11/01/2024

SUBJECT: Reserve @ Mitchell Mill 5th Submittal PSP-23-03 TRC Summary Comment Response

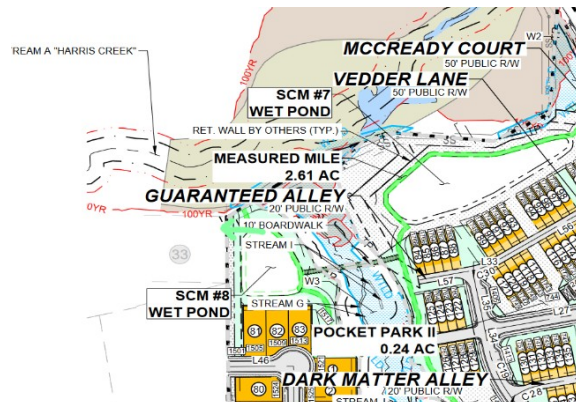
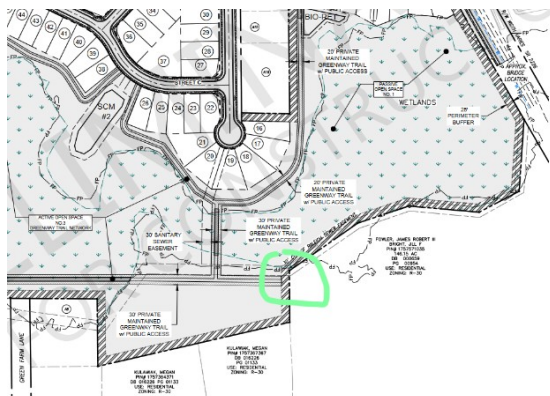
Follow up comment: Please add a table (Sheet C-12.9 would be a good place) summarizing the trees removed and showing the number of trees replacing them. This table should demonstrate compliance with the section and guidance above.

SREG RESPONSE: Sheet C11.9 shows an updated table of trees to be removed and a subsequent table of newly proposed trees. Thank you

WR Response: The “Total Newly Proposed Trees” table does not provide a calculation for staff to determine compliance with LDO 6.2.4.5, only a total of provided trees. Please update this table on Sheet 11.9 to include a breakdown of how proposed tree totals were determined.

SREG RESPONSE: Calculations shown on sheet C11.9. Trees replacement provided in Future CD submittal
